WICHITA WATER WALK

THE CITY OF WICHITA
SEDGWICK COUNTY. KANSAS
MICHAEL E. LINDEBAK, CITY ENGINEER

WICHITA WATER WALK
WICHITA, KANSAS
FOR THE
CITY OF WICHITA

COVER SHEET

DESIGNED:	JRH
DRAWN:	RT
CHECKED:	FVP
DATE:	10/30/1996
PROJ. NO.	95075
SHEET TITLE	DEMOLITION PLAN (NORTH)
DRAWING NO.	CD-1a

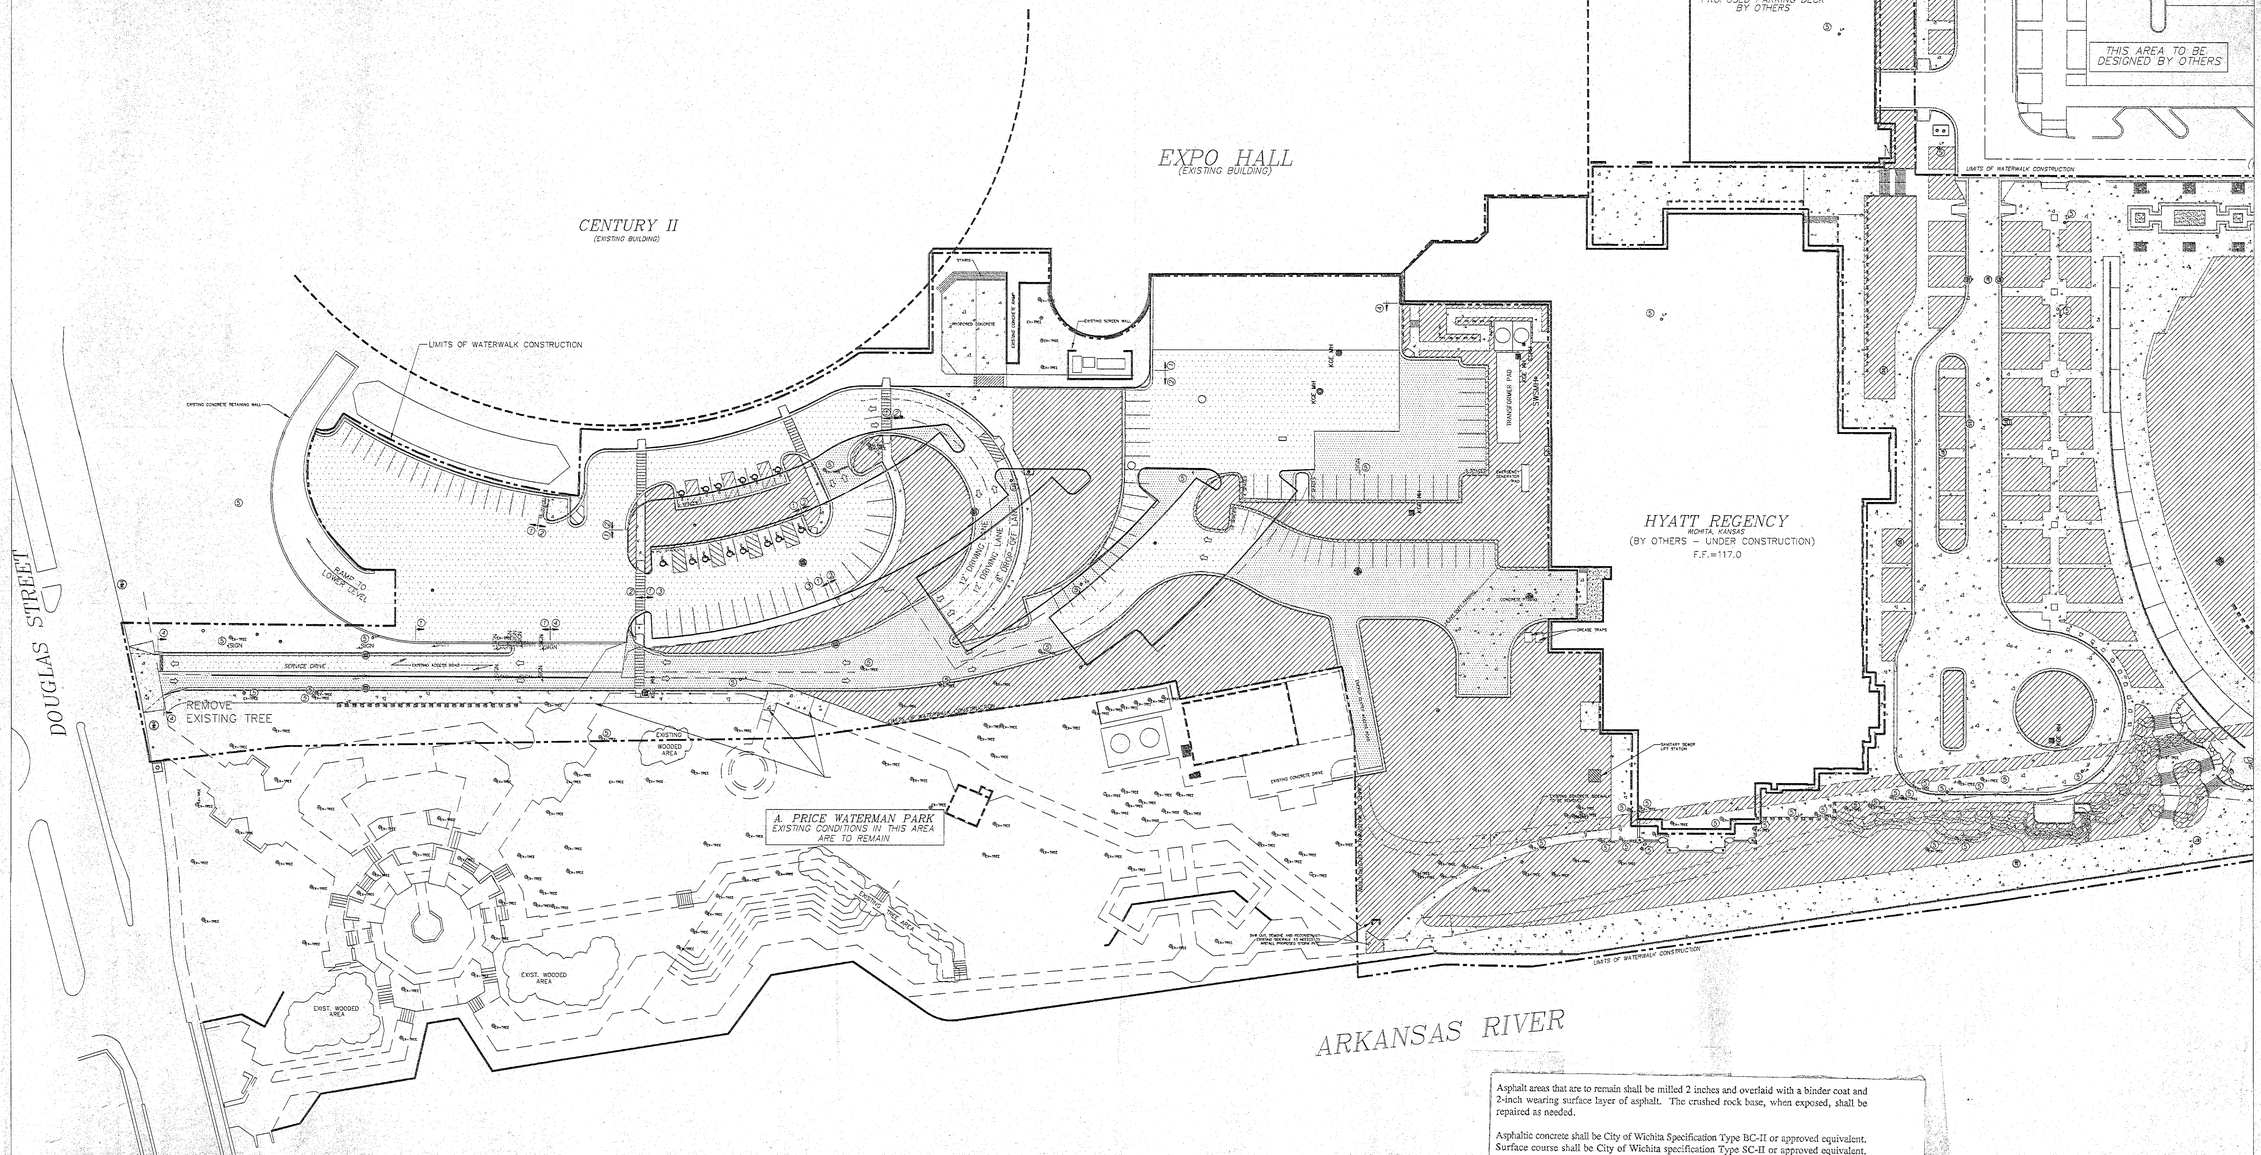
Eight-inch concrete paving as shown on the Miscellaneous Details, Drawing C-18, is correct. The Bid Form and other areas where this is referenced in the Contract Documents should be revised to reflect this.

Areas to be resurfaced and areas to have new asphalt paving are shown on the Demolition Plan, Drawing CD-1a, of the Project Plans.

a. 5,680 square yards of the area is new 10-inch asphalt with a 6-inch crushed rock base.
b. 7,890 square yards of the area is to be milled 2 inches and resurfaced with a tack coat and asphalt as specified.
c. The thickness of the heavy-duty paving is 10 inches (2 inches of asphaltic wearing surface and 8 inches of bituminous base placed in 2 lifts). The 10-inch pavement is underlain by 6 inches of crushed rock base.
d. The thickness of the subgrade is 6 inches and is crushed rock. A bid item for a. and b. above has been added to the Bid Form and is included in this Addendum.

REFERENCE DATA Specification Section # ____ Pg. ____
Sheet No. S1 Detail ____

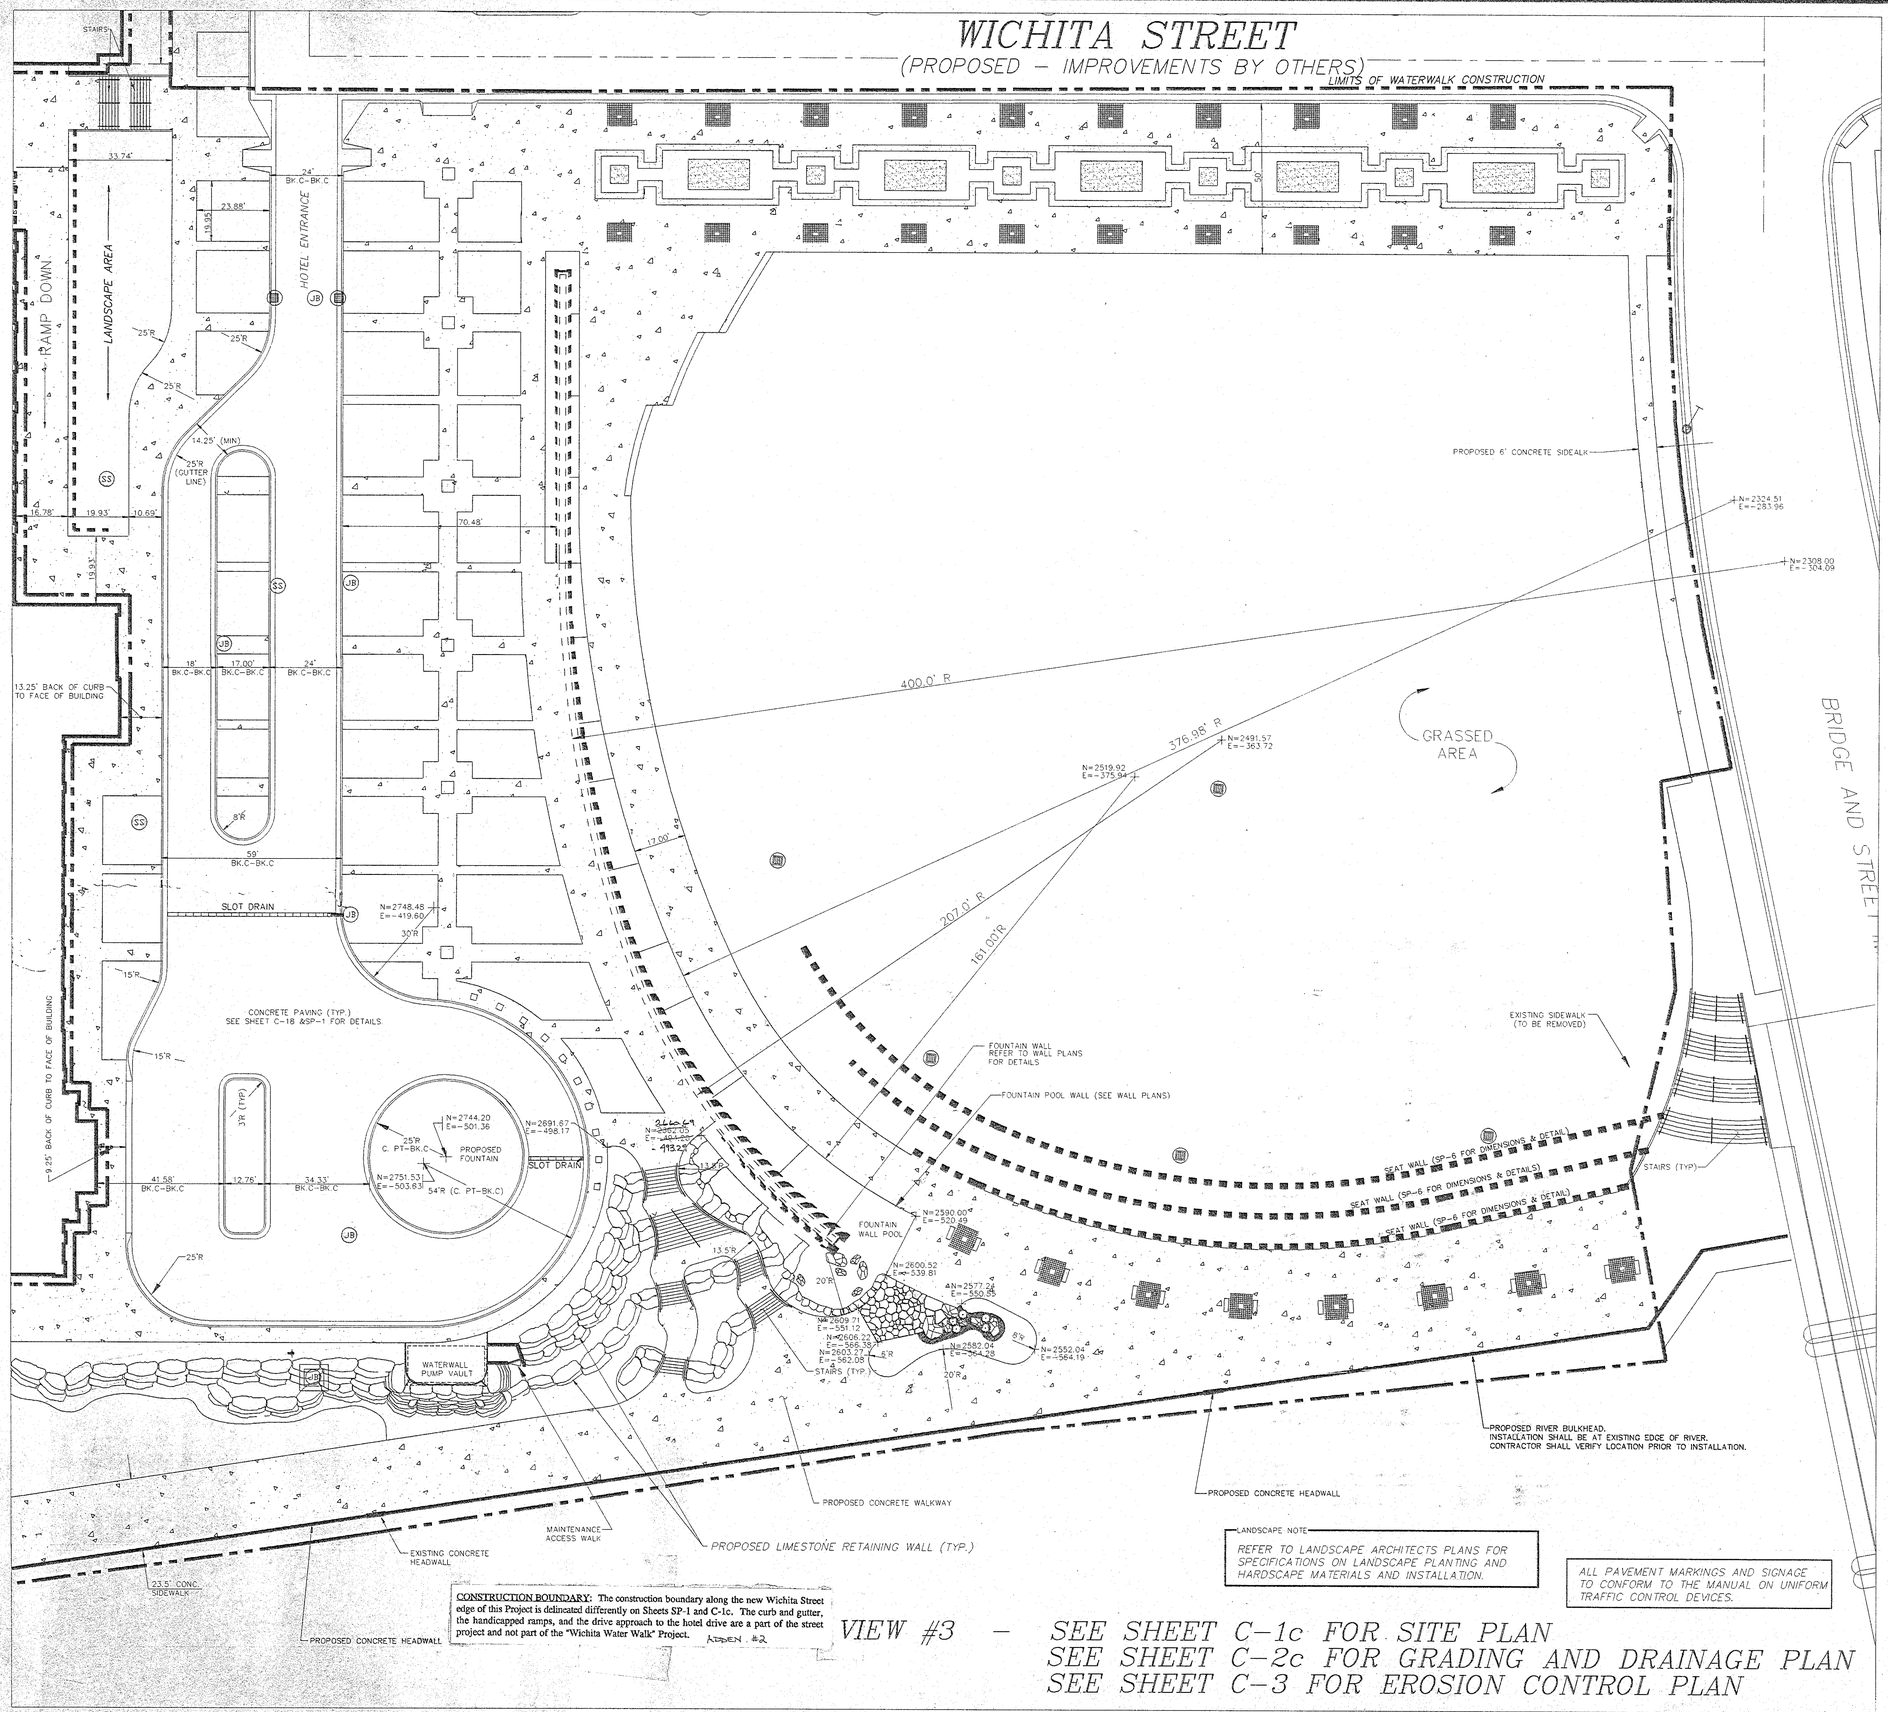
Information, Clarification, Interpretation is requested:
PLEASE PROVIDE THE COORDINATES FOR THE EAST AND WEST ENDS OF THE WATERWALL. ALSO PROVIDE THE "PC" COORDINATES FOR THE 90'S AND THE 207'S. (SEE THE ATTACHED DRAWING)

Please refer to the attached drawing and tables for the water-wall staking information. Please note that the dimensions correlate to the center line of the wall. If you have any questions or comments, please contact me.

DESIGNED:	FVP
DRAWN:	H.B.McD
CHECKED:	JRH
DATE:	10/30/1996
PROJ. NO.:	95075
SHEET TITLE:	MISCELLANEOUS DETAILS
DRAWING NO.	C-18

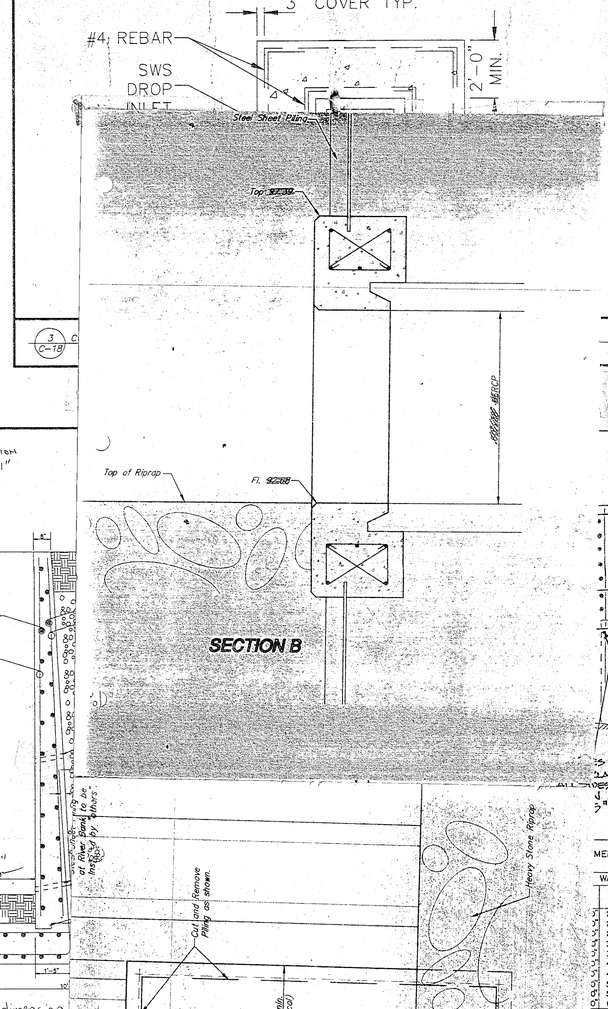
DRAWINGS, SHEET C-18, DETAIL 4/C-18: This detail includes a note that states, "Decorative stone face material to be selected by Owner. Contractor shall provide masonry ties in wall max 3'-0" O.C. each way for anchoring stone. Maximum thickness of stone face is 8"." This note should be modified to read, "All exposed surfaces of retaining walls shall be finished to match the exterior insulation and finish system (EIFS) material of the hotel exterior. Contact Kevin Russell at Midwest Drywall, phone (316) 772-9559, for material and application information."
ADDEN. #2

The 10-inch asphalt pavement shall have 4 inches of asphalt under the 6-inch curb. The 8-inch concrete "pavement" shall have no asphalt under the 8-inch curb. Where the two types of pavements meet, the full depth of asphalt shall be maintained, and the concrete pavement shall be thickened as needed.

ADD ALTERNATE #2
HOTEL WATER FOUNTAIN - ENLARGED PLAN

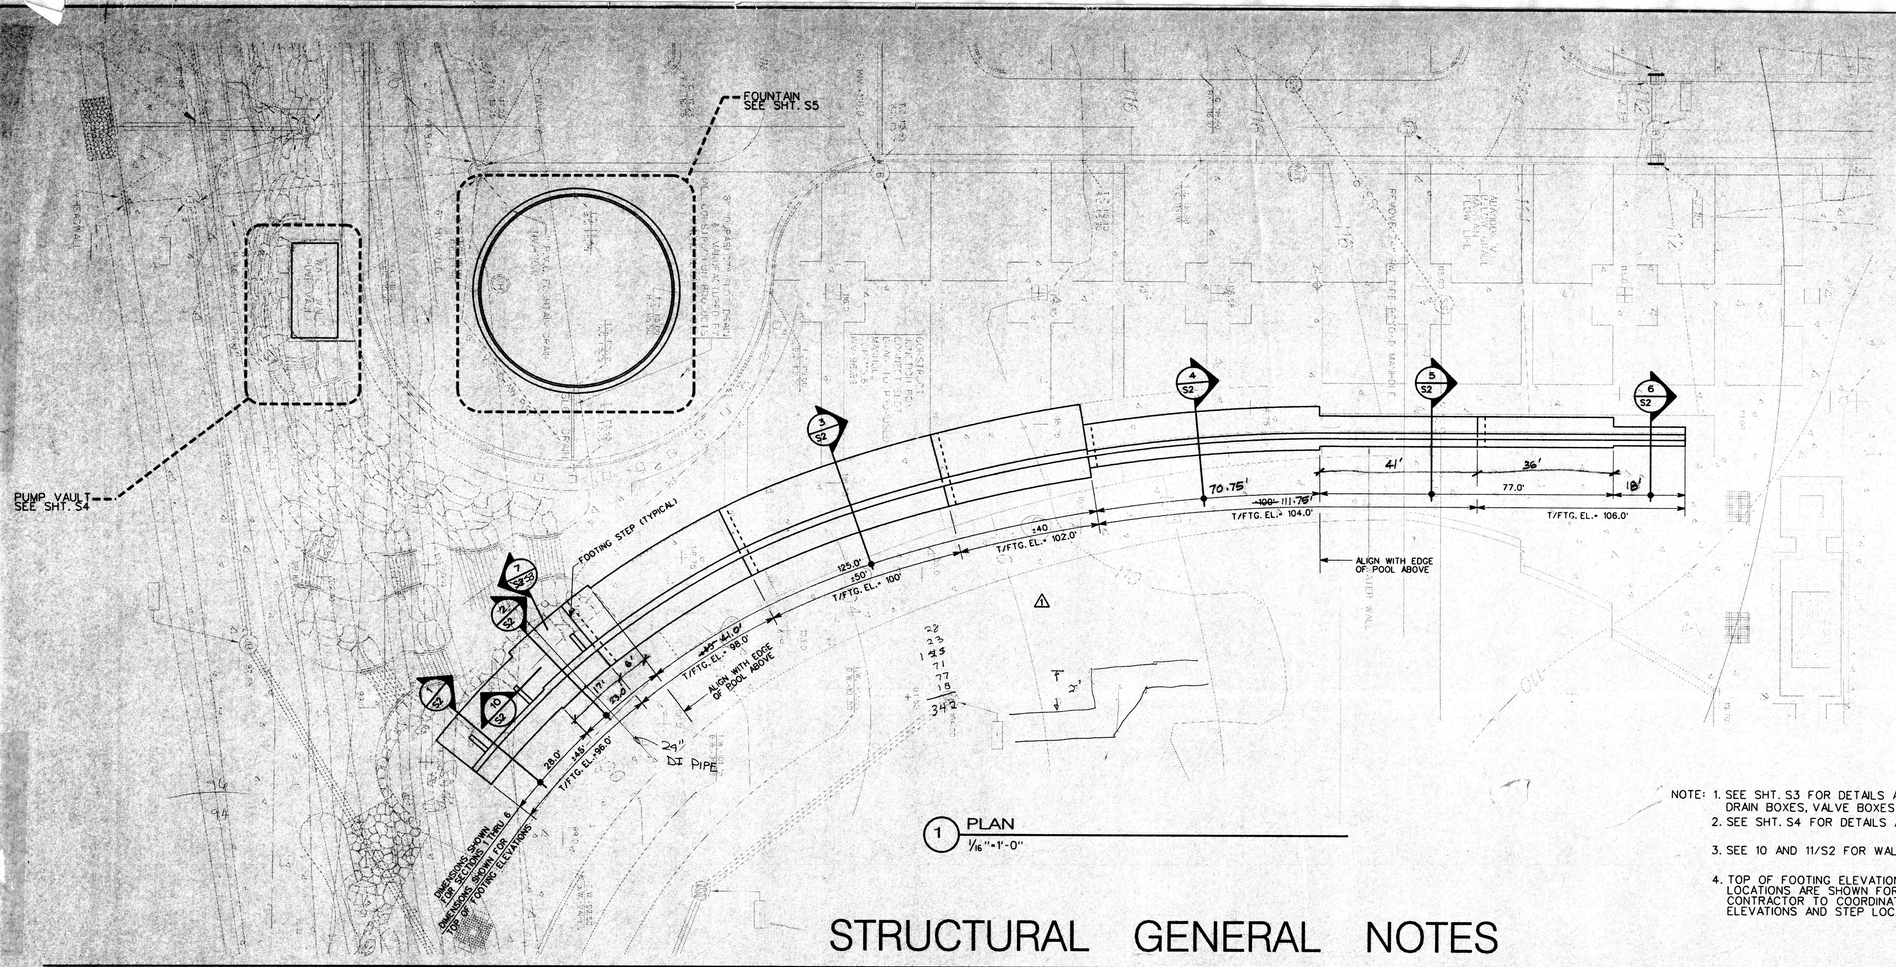
DRAWING SP-7: For details of fountain footings, refer to Sheet S5. Details 2, 3 and 4 are for the purpose of showing the attachment and placement of the precast concrete. Also, cast stone is an acceptable substitute for the architectural precast concrete wall facing and wall caps detailed on this sheet and specified in SECTION 03450 - ARCHITECTURAL PRECAST CONCRETE.

5 SECTION
3/4"=1'-0"

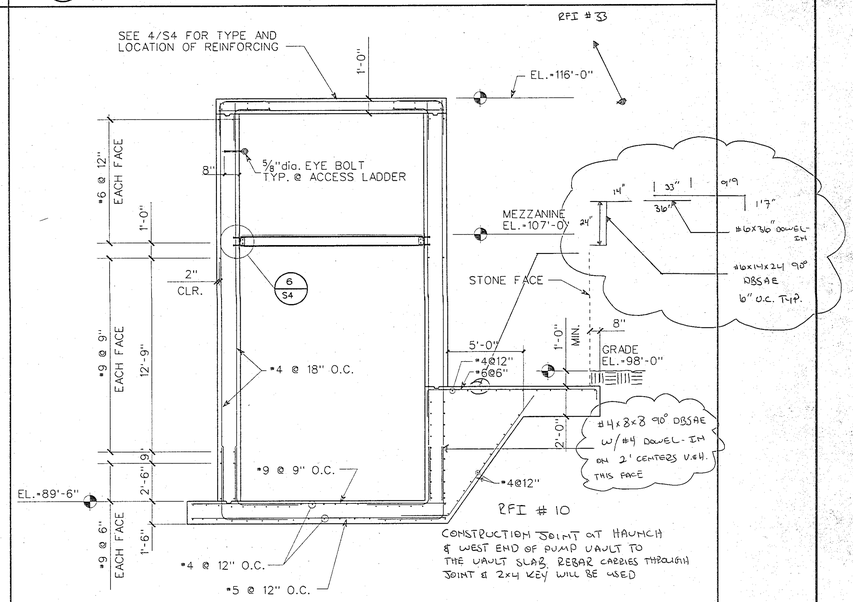
RFI # 10
CONSTRUCTION JOINT AT HAUNCH & WEST END OF PUMP VAULT TO THE VAULT SLAB. REBAR CARRIES THROUGH JOINT & 2x4 KEY WILL BE USED

WICHITA WATER WALK
MK EBY CONSTR. CO. #22100
PUMP HEADER DETAIL
PSE Co. JOB No. 5805
MRT 12/30/96
SHT 1 OF 1
REV. 1 2-17-97

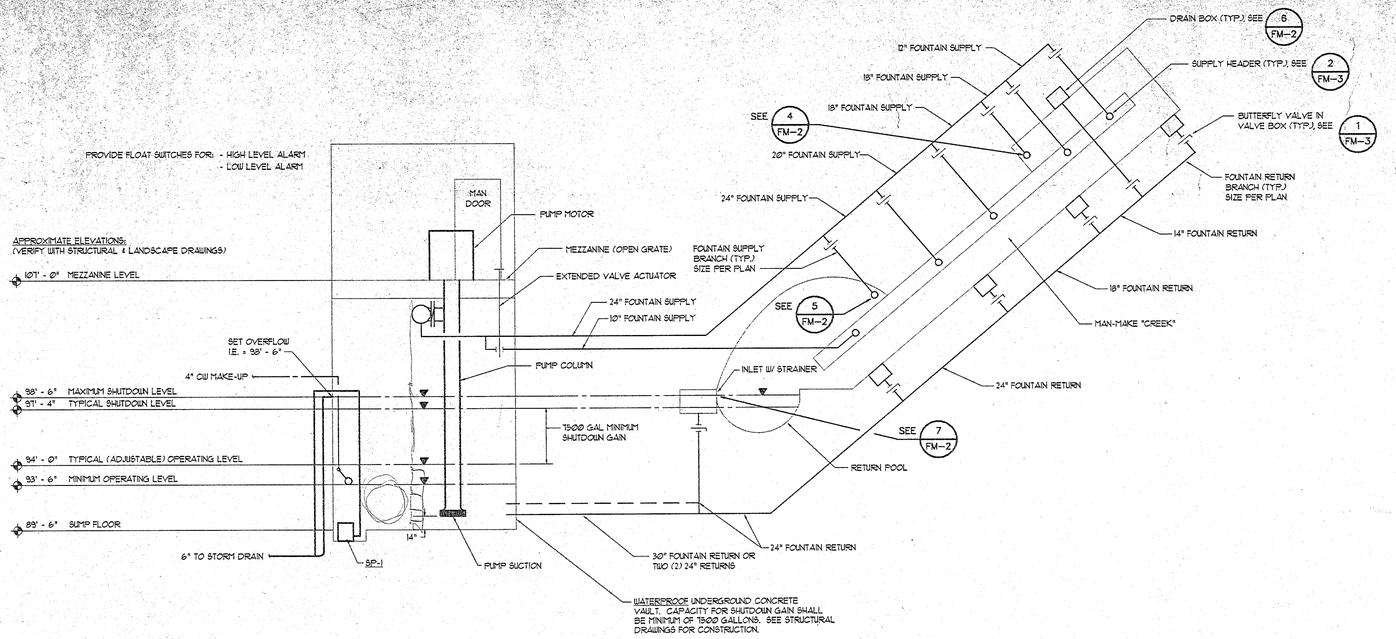
- [ ] REVIEWED
- [x] REVIEWED AS NOTED
- [x] REVISE AND RESUBMIT ← SHEET 2
- [ ] REJECTED

2 / FM–3 FOUNTAIN SUPPLY HEADER DETAIL
NO SCALE

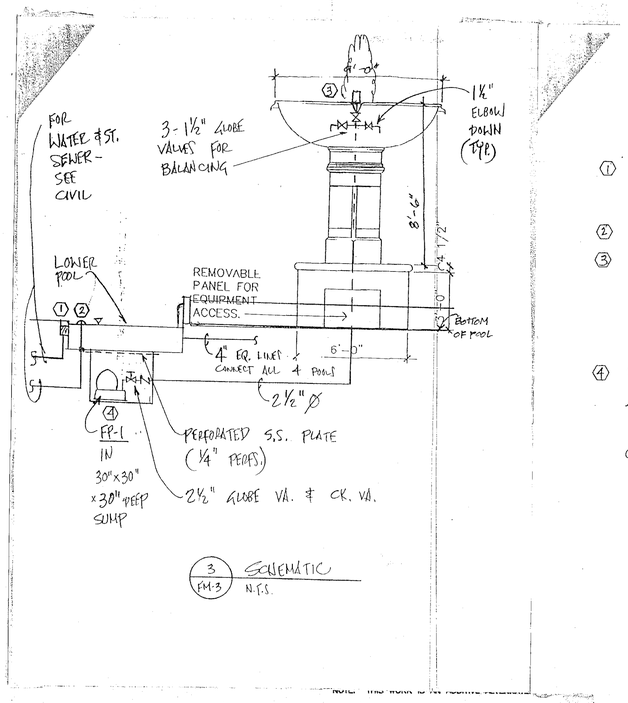
DRAWING SHEET FM-3, DETAIL 2/FM-3: Add the following note to this detail: "Stainless steel pipe for supply headers to be Schedule 10S, Type 304, ASTM B36.19. All joints to be welded. Support brackets to be Type 304 stainless steel; fabricated from ⅛-inch bent plate."
ADDEN. #2
